ANN ARBOR HISTORIC DISTRICT COMMISSION

Revised Staff Report

ADDRESS: 616 W Madison Street, Application Number HDC19-052

APPLICATION: The applicant seeks HDC approval to install a gas meter on the west front elevation, just south of the chimney.

Site:	616 W Madison Ann Arbor MI 48103	Drawing: 801506	Project: 0000616	Drawn: MAW	Notes:	Mike Weinhold 616 W Madison Ann Arbor, MI 48103
Title:	Move DTE gas utility meter	Scale: 3/32":1'0"	Date: 3/21/2019	Rev: A

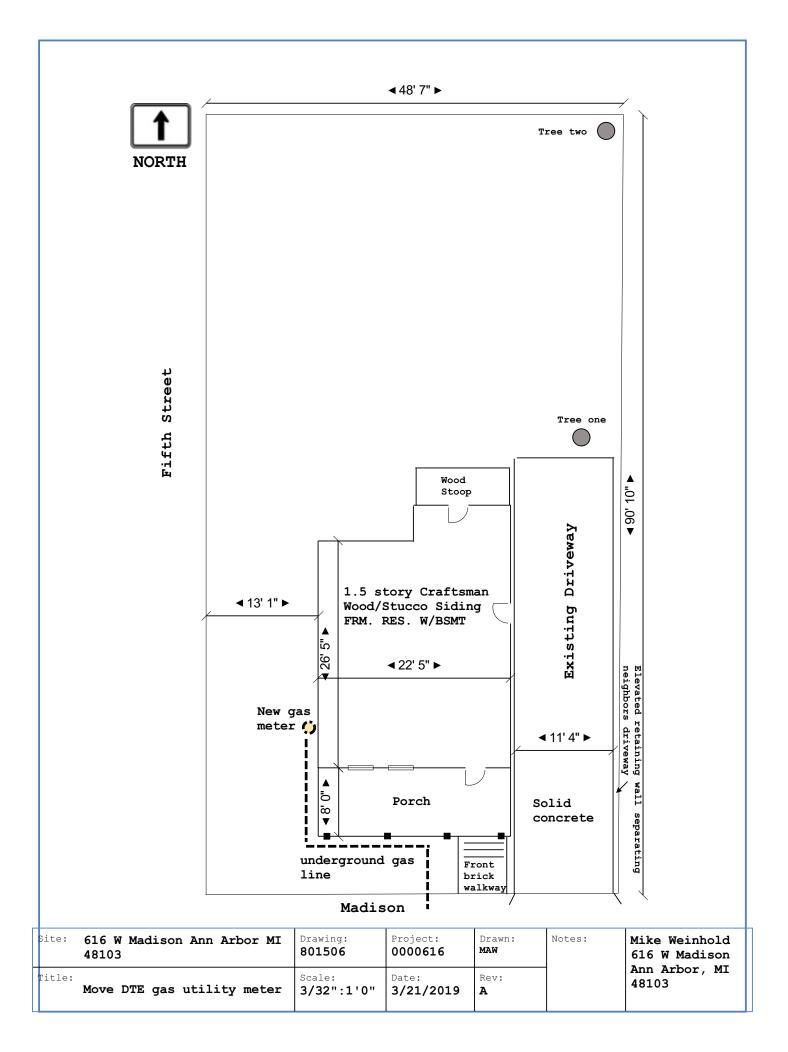
west elevation of the house, south (or to the right) of the brick chimney. It is proposed to be behind existing bushes. The homeowners state that they would like the current interior meter moved out of the basement to facilitate a laundry room remodel. The current gas service appears to run under the driveway off West Madison, and enters the house on the east elevation underground.

- 3. The application states that the exterior meter cannot be located on the east elevation because of the proximity of the narrow driveway (see application photos). When asked about placing the meter on the north (rear) wall of the house, the homeowners explained that there is an egress window close to the southwest corner, then an AC unit, then a rear entrance. If the west elevation is the only place a new meter can be located, the commission must weigh the proposal against the standards and guidelines. Questions to consider include:

Staff believes that unless a stronger argument is made for moving the meter, the most appropriate action would be to leave the interior meter in place. If the Commission believes it is appropriate to move the meter, the west elevation appears to be the only available place to put it, in which case adequate screening would be imperative.
